Memorandum

Re: Canada Line - Operations and Maintenance Centre Memo to Development Permit

Panel for May 24, 2006

SECTION :NORTH PROP. LINE

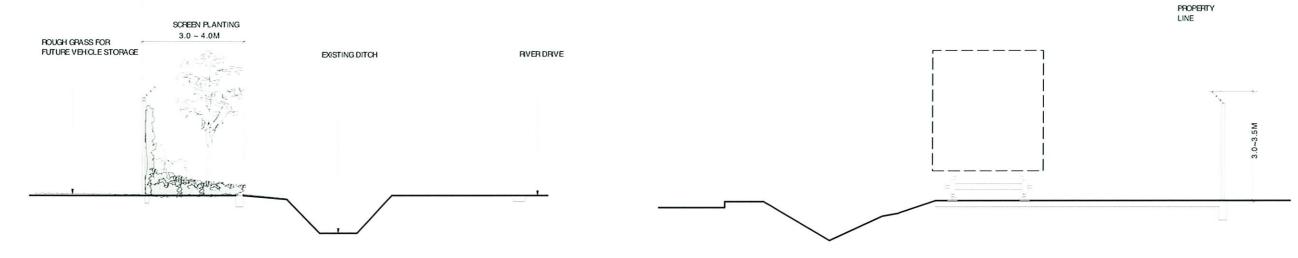
Comment: Chain link fencing with either barred or razor wire is unacceptable as a perimeter treatment and more sophisticated security provisions should be incorporated into the design. The design of the OMC does not provide for a continuous, perimeter landscape treatment and frontage improvements along adjacent road are minimal. The majority of this 7-acre site is to be covered in ballast material (i.e. gravel) and little attention has been given to aesthetic appearance and treatment of the ground plane. The OMC main entry and arrival sequence should consider visitors as well as employees and provide for significant tree planting, landscaped parking areas, pedestrian walkways and bicycle connections to the facility.

- A landscape plan for the OMC.
- Enhanced landscape improvements around the entire perimeter of the OMC.
- More sophisticated security measures including surveillance cameras, security patrols, higher quality perimeter fencing and a continuous perimeter landscape treatment that incorporates layers of plant material as screening to the rail yard.
